APPENDIX K
: INFORMATION OF CLASS II PERMISSIVE CHANGE

Information of Class II Permissive Change

EUT Type: Remote Controller
Model No.: TX-1000
FCC ID.: OZ5URCTX1000
Applicant: OHSUNG ELECTRONICS CO., LTD.
Trade Name: URC

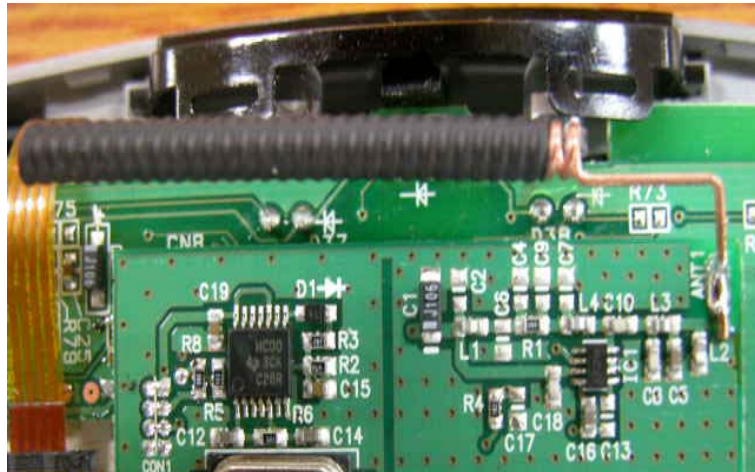
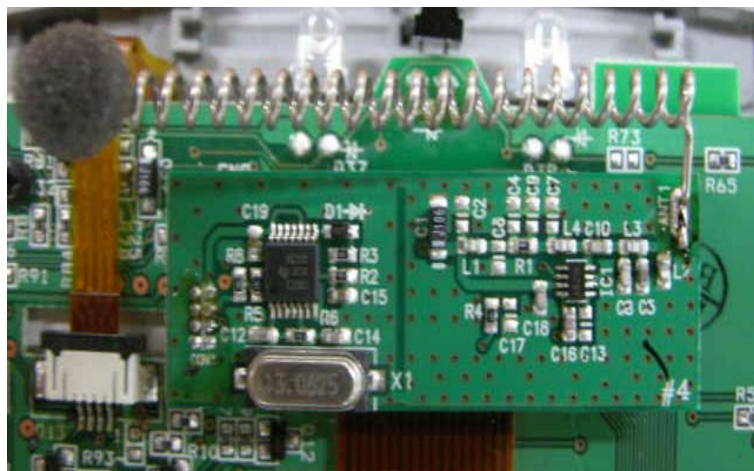
2.1 Changed the antenna material from Copper to Nickel for improving RF transmitting characteristic
